COMMISSION FOR HISTORICAL & ARCHITECTURAL PRESERVATION

STAFF REPORT

REQUEST: Approval of Subdivision Plan including Concept Approval of Height, Massing and Scale of 14 Houses

ADDRESS: Various Addresses along Hill Street/Freeman's Oval in Franklinton, Baltimore

Image 8 – View of Hill Street Oval from directly above, December 2016

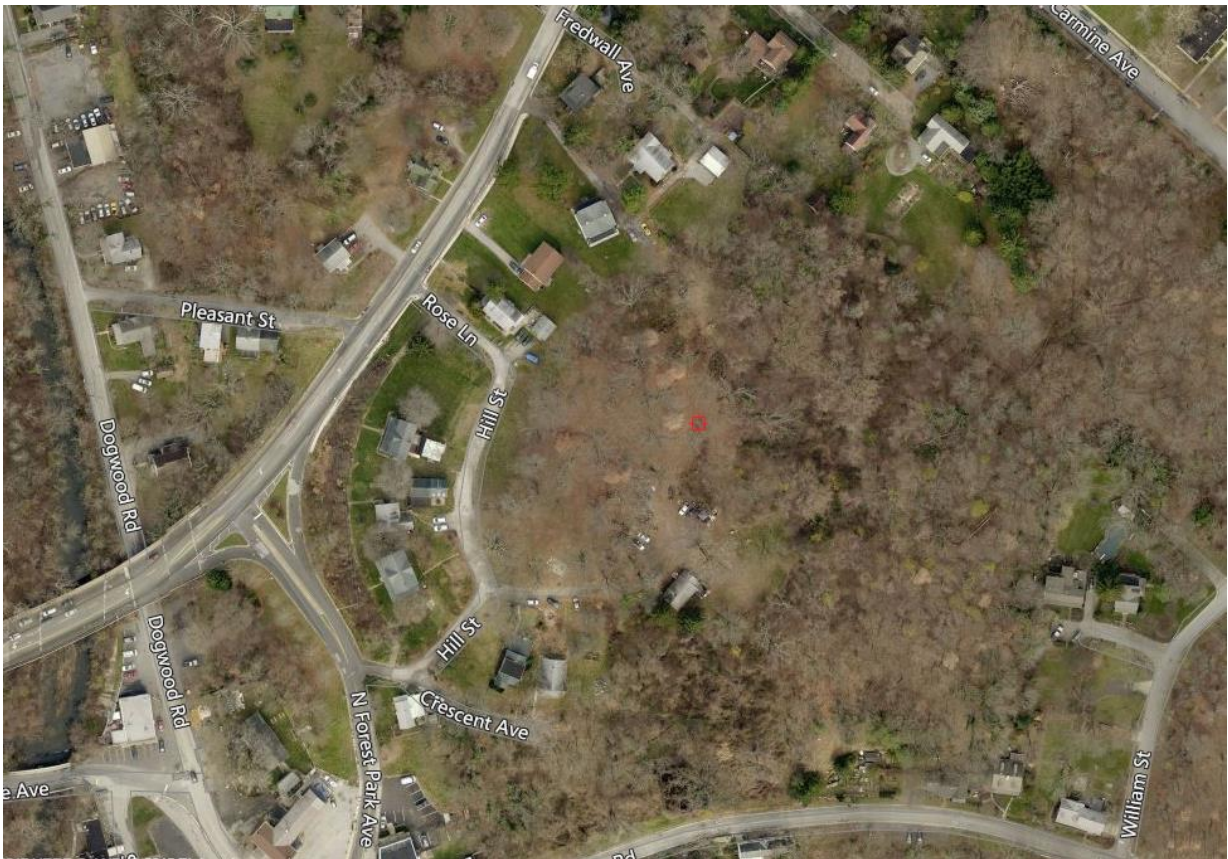
Hill Street, which would have been the inner ring of a double-ringed plan shaped like a race course, today is essentially a U shape, with its northern half never realized (*Image 8*). Hill Street starts at Rose Lane on the west side of the central green space and curves south and then east and north to end just past 1715 Hill Street (*Image 9*). Crescent Street, the envisioned outer ring of the plan, is even less defined. N. Forest Park Avenue replaced some of Crescent Street

Image 16: Tree Study, Hill Street/Freeman's Oval, Randy Bernstein of Arbor Master, March 2017

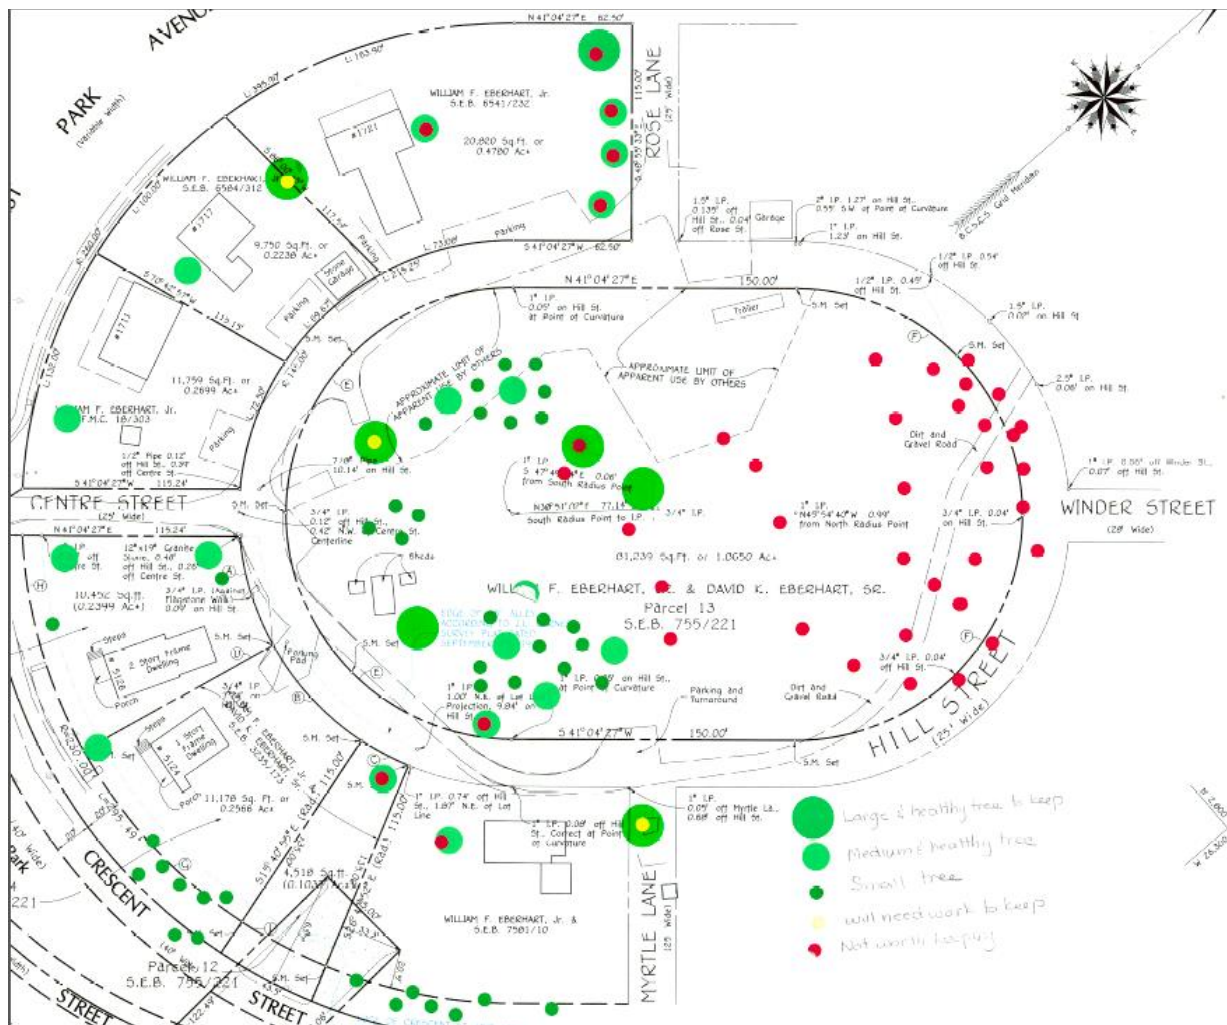
An inventory of the trees on the property was commissioned in March 2017 (*Image 16*). Arborist Randy Bernstein assessed the size and condition of the trees. The majority of the mature and health trees appear to be at the south end of the park land, the area intended to be preserved as a commons—which would meet the guidelines. The developer will need to submit a Forest Stand Delineation as part of the City Planning approval process.
